ADDENDUM NO. 1

SRC NORTH COOLING TOWER REPLACEMENT

PROJECT NO. 957448

December 19, 2019

VIBRATION ISOLATION RAIL DETAIL

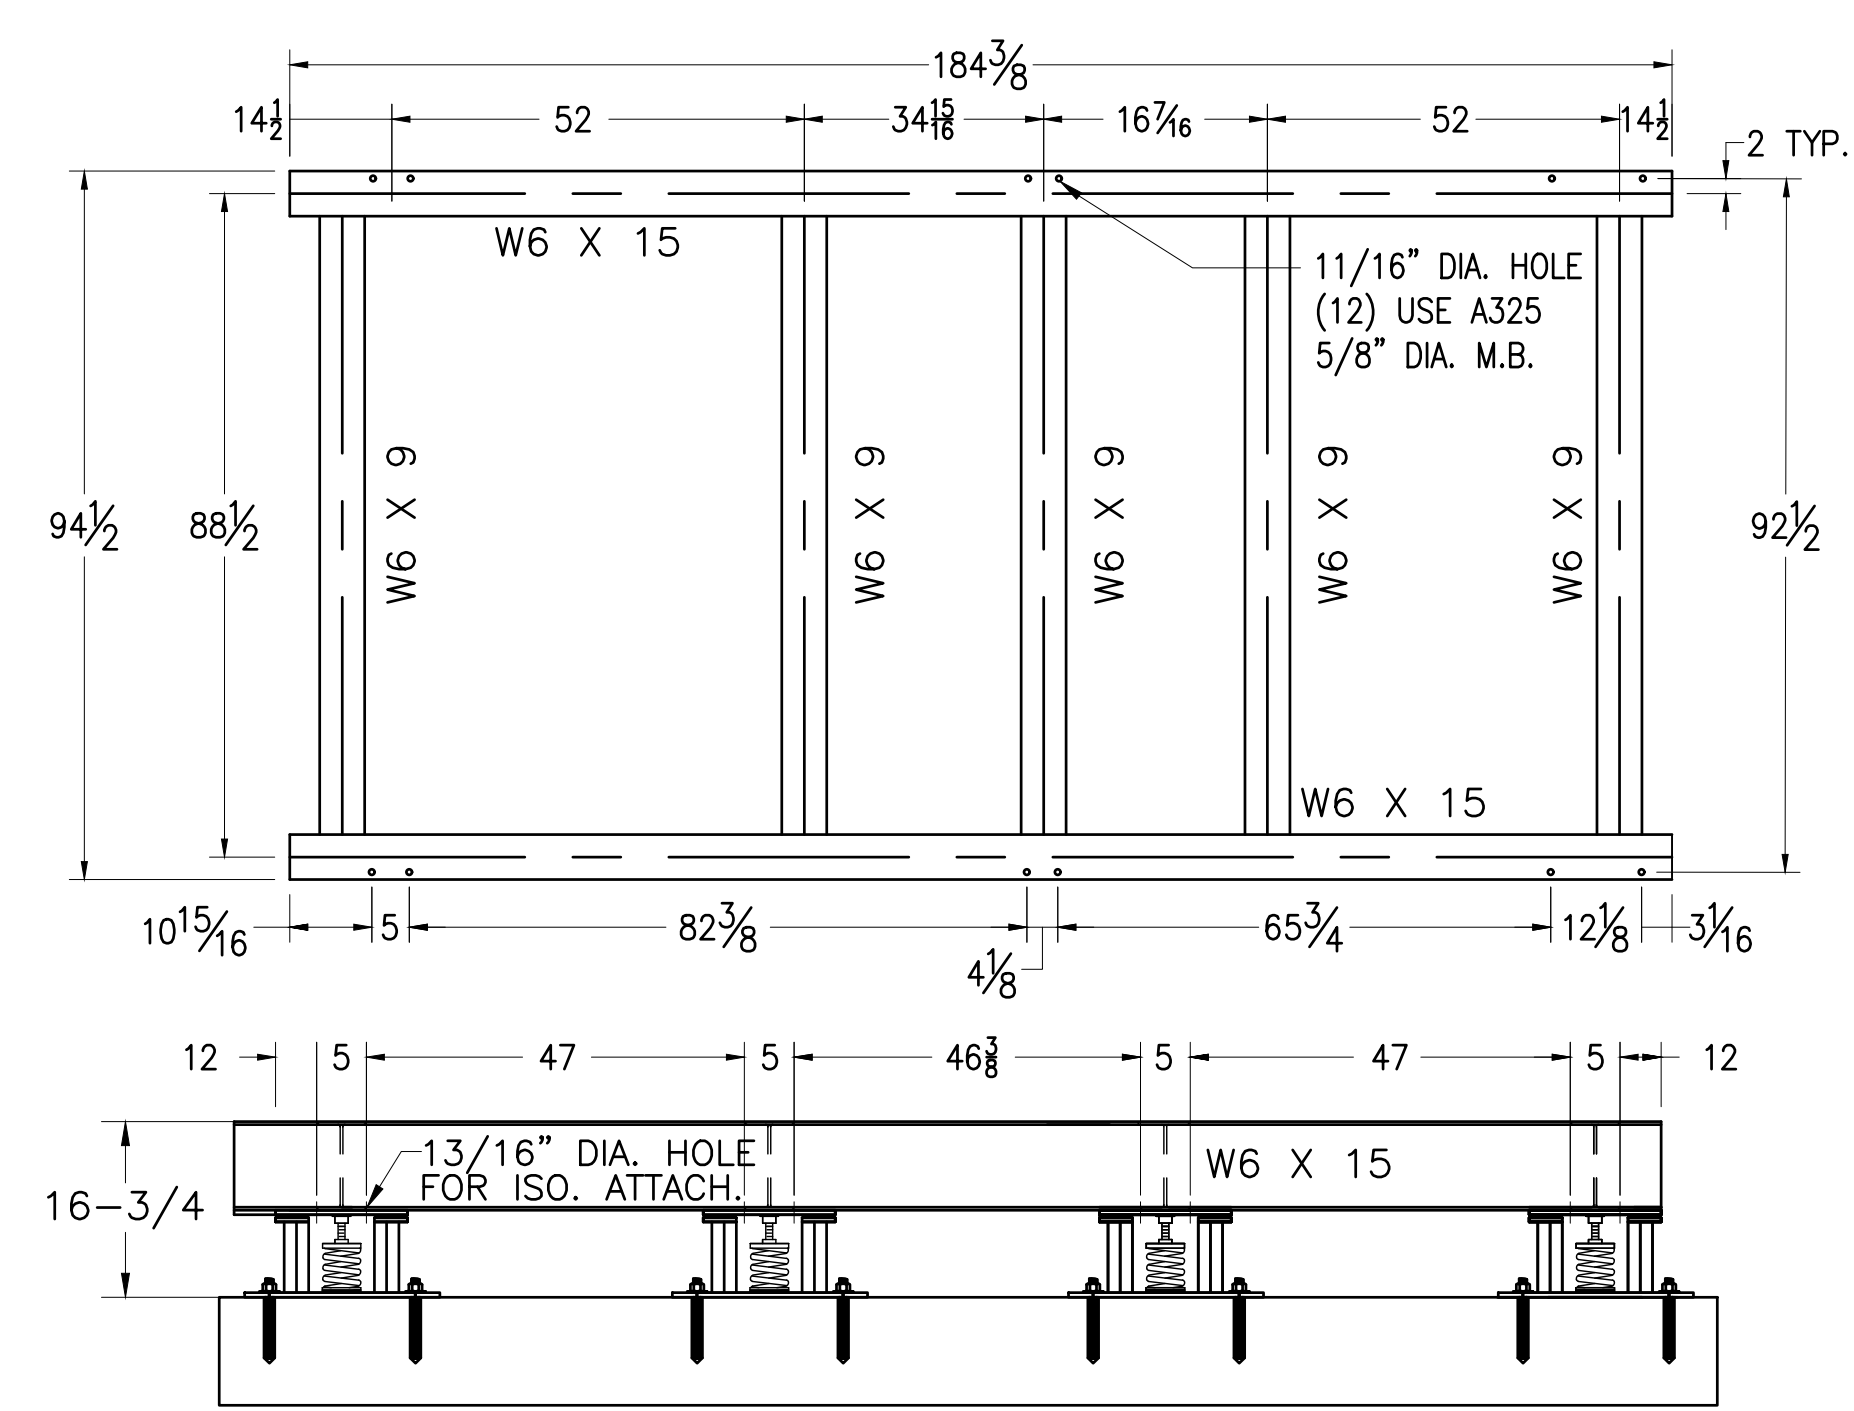
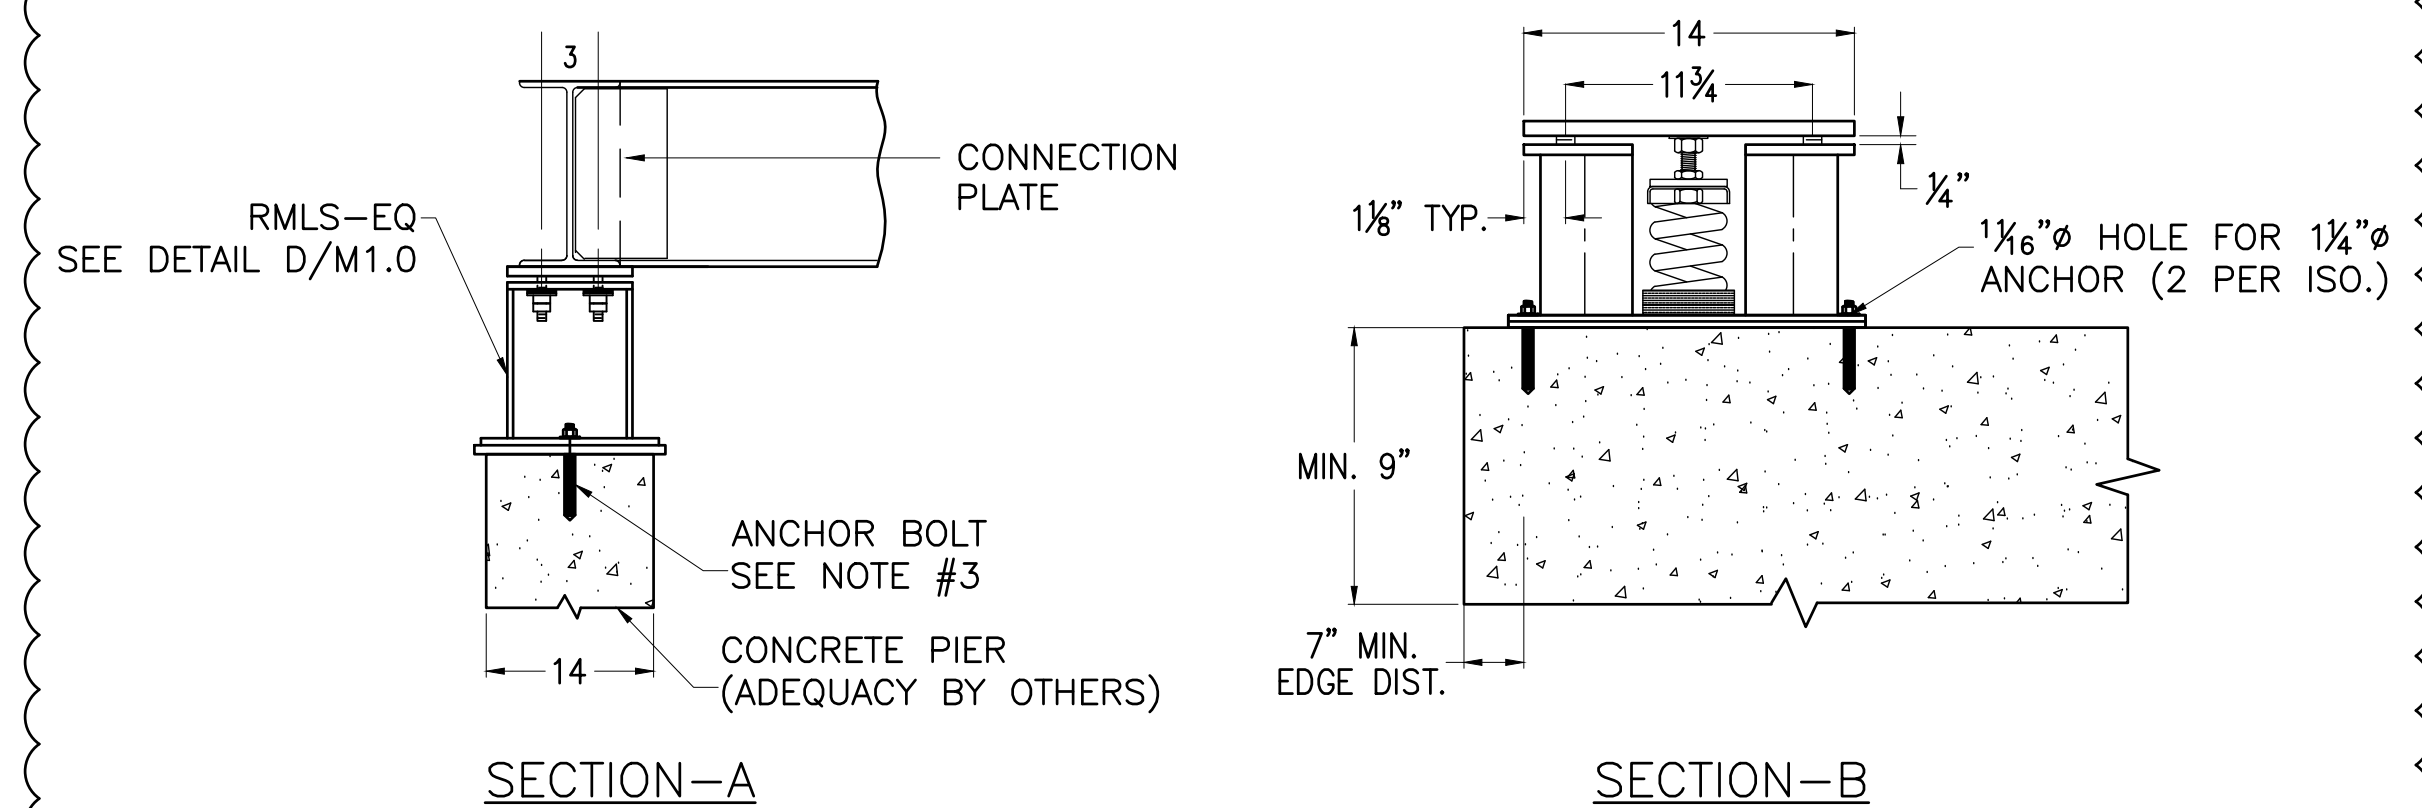
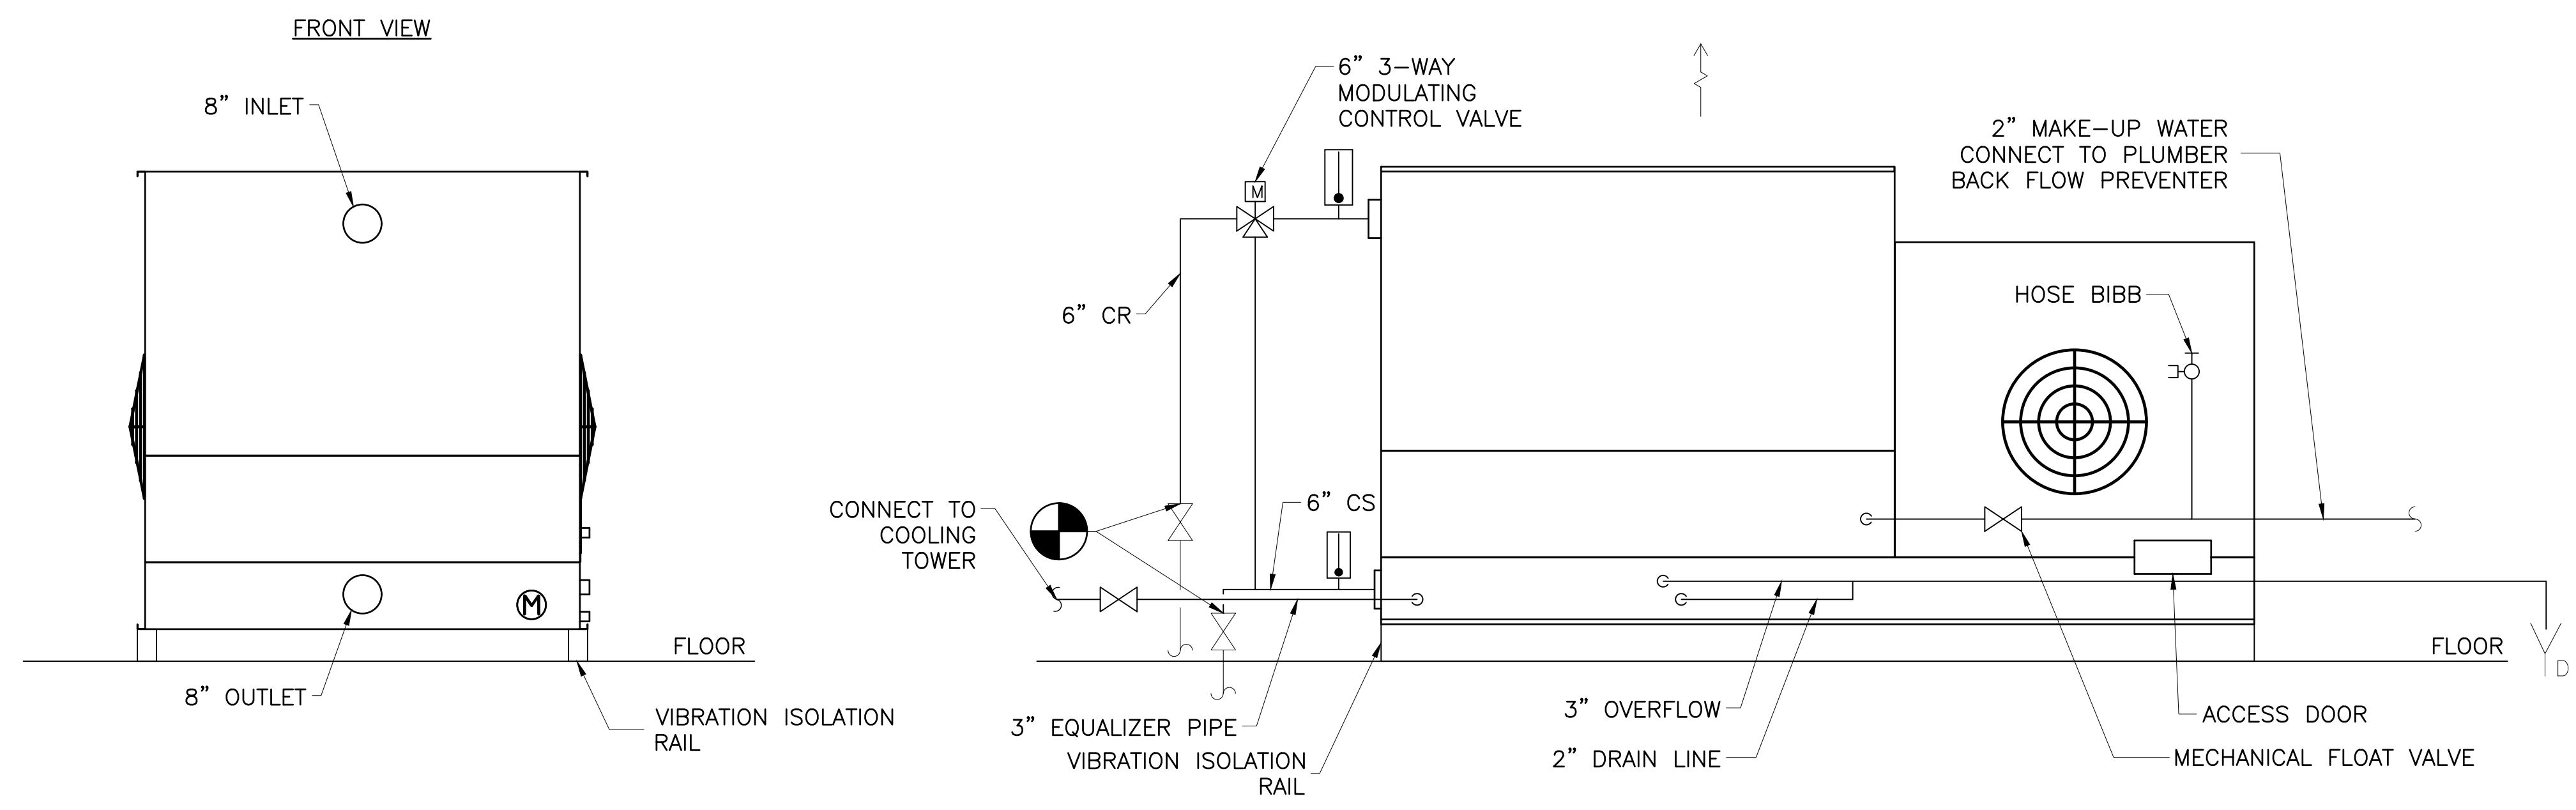
<p>one of the cooling tower piers protrudes less than 3" from the roof. The detail will not be able to be installed. Please advise. Additionally, during the pre-job conference, it was stated that no roofing was required / anticipated. The roofing currently proceeds up the sides of these piers. Roofing will need to be considered depending on the solution to this anchorage problem</p> <p>Answer: Please see the attached updated detail for the mounting of the towers.</p>
1-13	<p>Question: The existing concrete pillars supporting the existing cooling tower CT-1 are not tall enough to install saddle plates as shown in details. The pillars are shorter on this tower than the other. Concrete pillars are approximately 3" inches tall on one side and 6" inches tall on the other side. In lieu of side saddle plates, can we extend the top sub plate on each side of the isolator and add mounting holes on top for anchorage. Would this application be acceptable? Please see attached hand sketch of proposed application.</p> <p>Answer: Please see the attached updated detail for the mounting of the tower.</p>

Drawing Title: **CONTROLS DIAGRAM + SEQUENCE OF OPERATIONS** Sheet No. **M5.0**

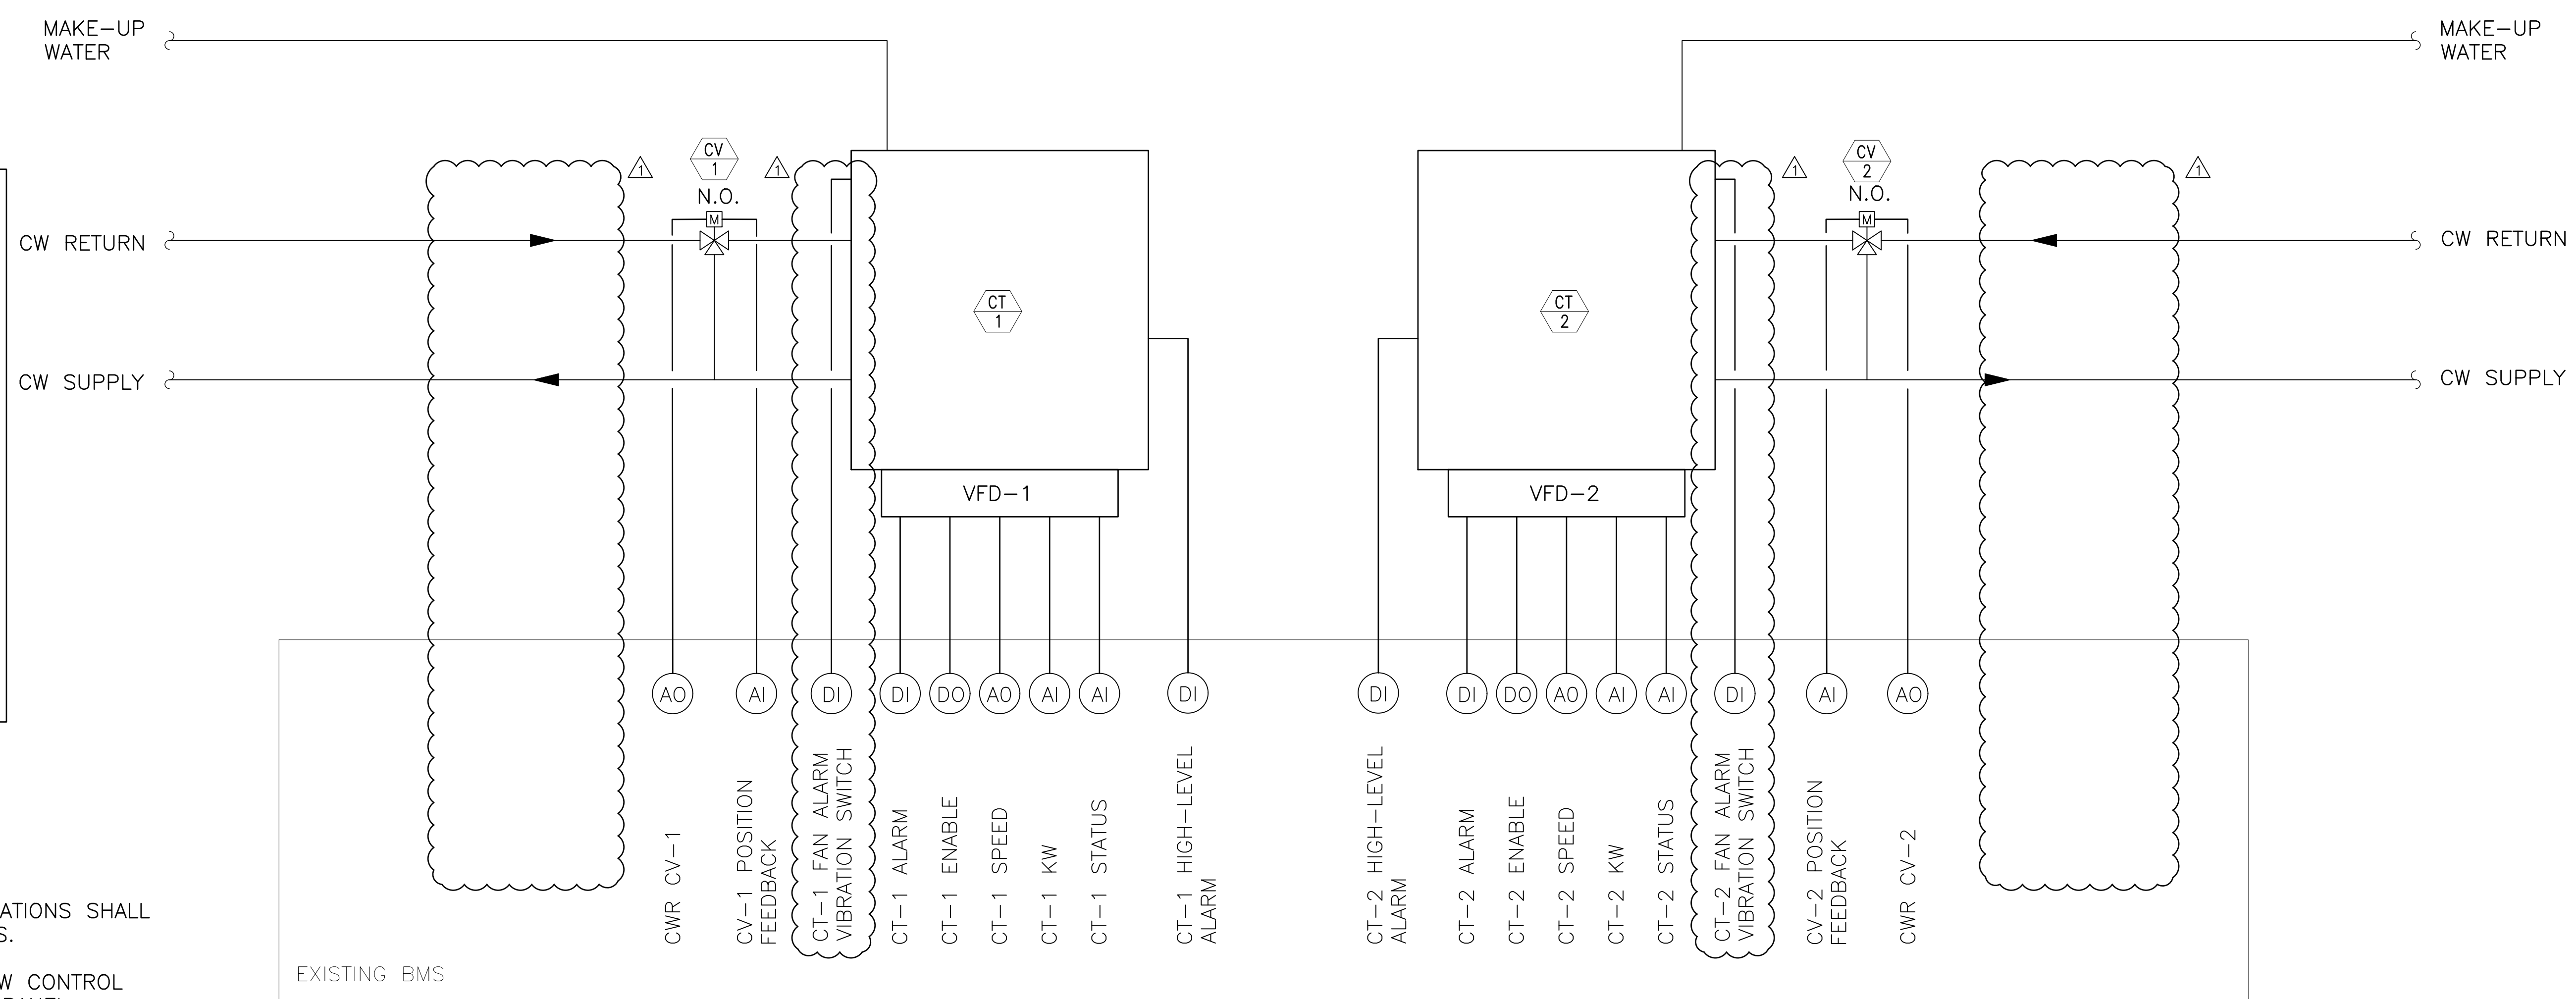
RFI No.	QUESTIONS / ANSWERS
1-1	<p>Question: Reference E0.1, E1.0, E3.1: Are cooling tower vibration switches going to be added to project for VFD/Fan shutdown?</p> <p>Answer: Yes, the cooling tower vibration switches are added to the project for VFD/Fan shutdown. Please refer to M5.0 for additional information.</p>
1-2	<p>Question: Reference E0.1, 1.0, 3.2: During job walk we did not see room below cooling tower – is it safe to assume vacated electrical conduits thru roof can be used for added cooling tower control points e.g. CWS/CWR temperature sensors?</p> <p>Answer: The existing condenser water system contains CWS/CWR temperature sensors. No need to provide additional temp sensors. Please refer to M5.0 for additional information.</p>
1-3	<p>Question: Reference E0.1,E1.0, E3.3: What is the scope for additional wiring to existing DDC panel?</p> <p>-Does existing panel have ample spare I/O for added points? -What type of control panel is it?</p>
